PROJECT
16965 LINDBERGH ROAD
N1/2, N1/2, NW1/4, SE1/4, SEC. 22, T.11S., R.67W.
EL PASO COUNTY

SHT. NAME
SITE DEVELOPMENT PLAN

Site Development Plan_V1.pdf Markup Summary

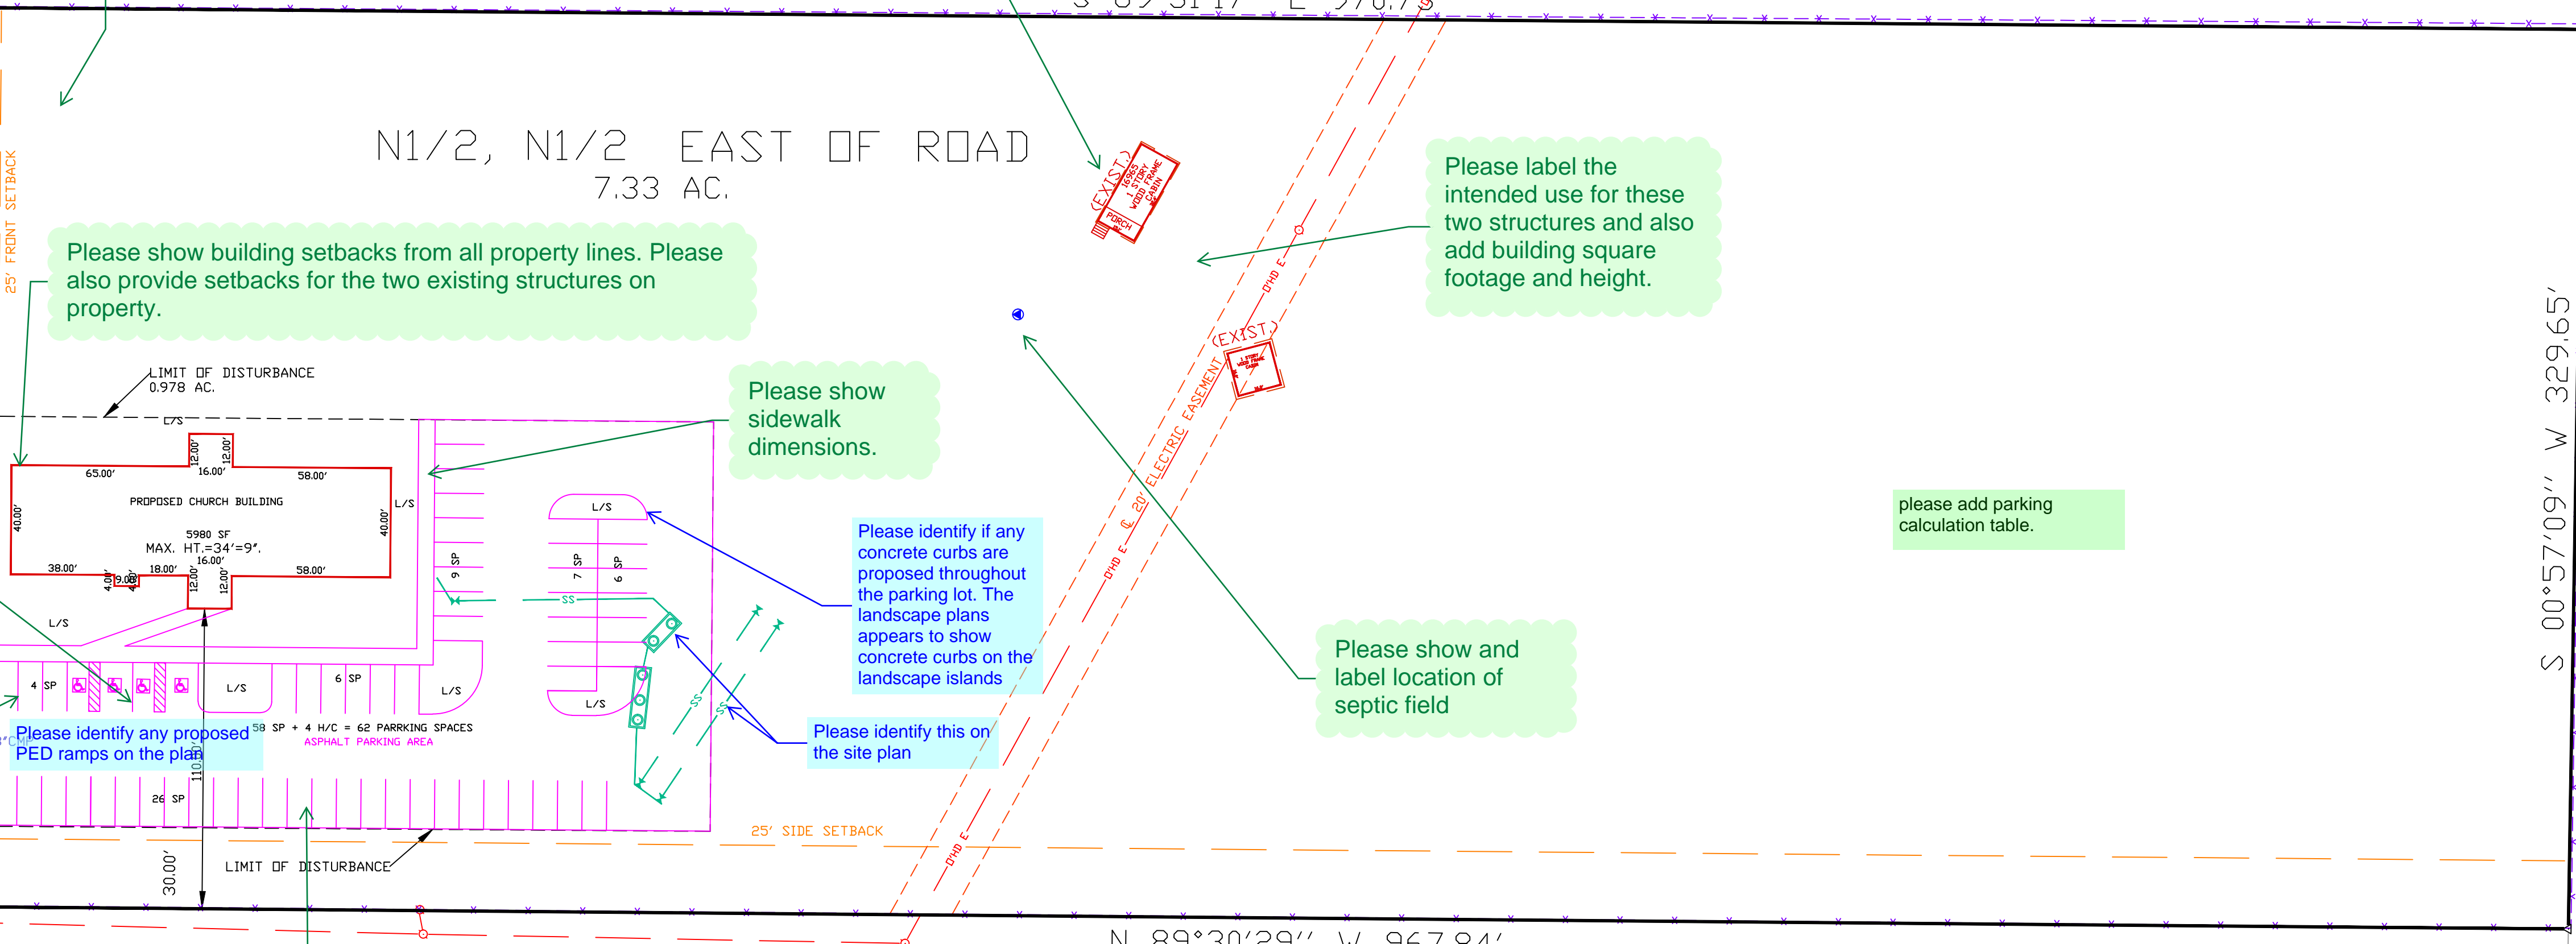
Please indicate where the refuse area is, and show a dumpster enclosure that is adequately screened per Chapter 6 landscape requirements - refuse areas screened (subsection in Code titled "other required landscape areas")

Please note that parking areas with more than 5 parkign spaces are required to provide lighting. Please provide us with a photometric plan showing lighting in the critical areas of the site (the area leading from parking area into the building).

Please show zoning and land use for all adjacent properties

How will the residents of the parsonage access those two existing structures? Is a driveway existing or proposed? Please show and callout access to the parsonage on the plan.

The letter of intent discusses a proposed gazebo in the northwest portion of the site. Please include this in the plan.

Please add bicycle parking. Per Chapter 6 LDC parking standards: "the minimum number of bicycle parking spaces shall equal 5% of the number of required parking spaces. At least one bicycle parking shall be provided."

Please show building setbacks from all property lines. Please also provide setbacks for the two existing structures on property.

Please label the intended use for these two structures and also add building square footage and height.

Please show sidewalk dimensions.

Please identify if any concrete curbs are proposed throughout the parking lot. The landscape plans appears to show concrete curbs on the landscape islands

Please show and label location of septic field

please add parking calculation table.

Please show and callout an ADA route from ADA parking spaces to building entrance(s).

Please provide County standard driveway detail. Please be sure to identify the proposed radius of the driveway

Please show dimensions of parking spaces, ADA parking spaces, and parking islands.

Please show width of drive aisle and width of ingress/egress.

The landscape plan shows islands on this southern parking row, and is inconsistent with the site development plan. Please revise site development plan/landscape plan to ensure consistency.
